Access Compliance Report

Public Rights-of-Way (Curb Ramps)

Intersection ID: N/A	Main Street: LITTLE ROCK RD	Cross Street: N/A	Location: S
ADA ID: 08325886692B	Ramp Type: PerpDiag	Initial Pass/Fail: Pass	Overall Compliance: No
			Severity Score: 10.25

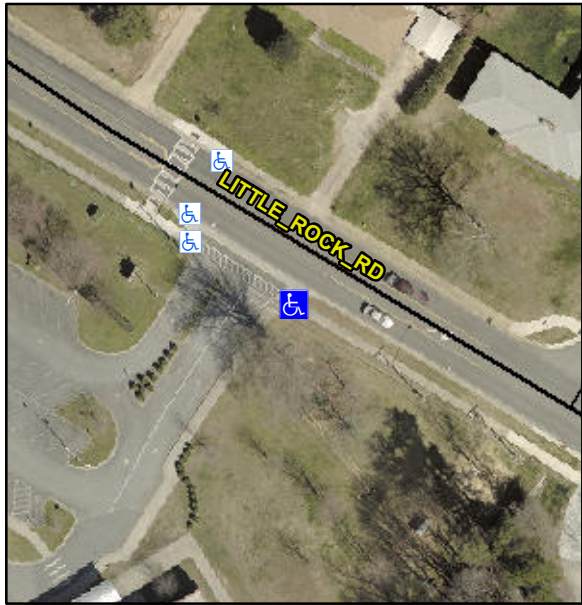
Codes/Mitigation Info/Possible Solution			Field Measurements/Component Compliance					
	Possible Solutions:		Compliance	Description	Data	Compliance	Description	Data
	Remove & Replace Curb Ramp With Two New Directional Ramps or Equivalent.		N/A	Ramp Length (in)	100.0	Yes	Ramp Slope (%)	5.5
			Yes	Ramp Width (in)	48.0	Yes	Ramp XSlope (%)	3.0
			N/A	Flare Type LT	Sloped	N/A	Flare Type RT	N/A
			N/A	Flare Slope LT (%)	9.0	Yes	Flare Slope RT (%)	0.7
			N/A	Flare Traversable LT?	Yes	N/A	Flare Traversable RT?	Yes
			No	Landing Length (in)	N/A	Yes	DWS Provided?	Yes
			No	Landing Width (in)	N/A	Yes	DWS Contrast?	Yes
			No	Landing Slope (%)	N/A	Yes	DWS Length (in)	24.5
			No	Landing X Slope (%)	N/A	Yes	DWS Full Width?	Yes
Surveyor Notes:		N/A	N/A	Landing Curb? (Y/N)	No	Yes	DWS Offset (in)	1.5
PROW/ADA:		Not Found, R304.2.1, R304.2.2-Perp, R304.3.2-Para, R304.5.3	N/A	Shared Landing?	No			
			Yes	Gutter Ponding?	No	Yes	Gutter Slope (%)	0.8

Yes	Gutter Lip Ht (in)	0.0	Yes	Gutter X Slope (%)	2.8
			N/A	Painted X Walk1?	No	N/A	Painted X Walk2?	Yes
				X Walk 1 Direction	To NE		X Walk 2 Direction	To NW
			N/A	X Walk 1 Width (in)	N/A	N/A	X Walk 2 Width (in)	58.5
				X Walk 1 Slope (%)	1.9		X Walk 2 Slope (%)	5.3
				X Walk 1 X Slope (%)	2.6		X Walk 2 X Slope (%)	1.9
			N/A	Ramp inside XWalk1?	N/A	Yes	Ramp inside XWalk2?	Yes
				Road Slope (%)	3.9	N/A	Clear Space?	Yes
				Road X Slope (%)	4.0	N/A	Clear Space to XWalk (in)	N/A
			Yes	Any Obstructions?	No	Yes	Storm Grate/Utility Hazard?	No
				Obstruction Type			Storm Grate/Utility Type	
					N/A			N/A
						Yes	Surface Condition? (G/P)	Good
